NEW DEVICE ALLOWS SAFER PARACHUTING

AVIATION AND
AIRBORNE
UNITS, DID YOU
KNOW THAT A
STATIC LINE
ANCHORING
DEVICE, NSN
1670-00-999-
3544, IS NOW
AVAILABLE FOR
PERSONNEL
PARACHUTING
FROM YOUR
BLACK HAWKS?

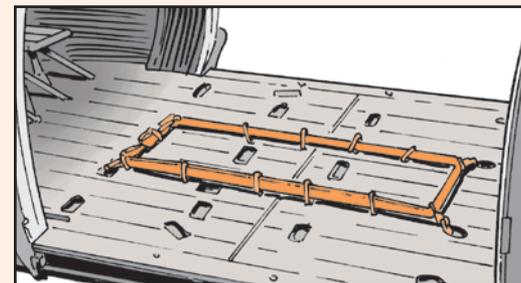
TO SOLVE THE PROBLEM, TACOM'S AERIAL
DELIVERY EQUIPMENT TEAM REDESIGNED THE
STABO LOOP SYSTEM TO CREATE A DEDICATED
STATIC LINE PARACHUTE ANCHOR DEVICE IN UH-60
HELICOPTERS. THE REDESIGN INCLUDED...

- larger D-rings to accommodate the universal static line snap hook. That allows for quicker rigging and derigging.
- a change in buffer material from cotton to nylon.
- new snaps hooks to take advantage of newer hardware.

IF YOU'VE BEEN USING STABO LOOPS FOR
PARACHUTING, REPLACE THEM WITH THE NEW
STATIC LINE ANCHORING DEVICE.
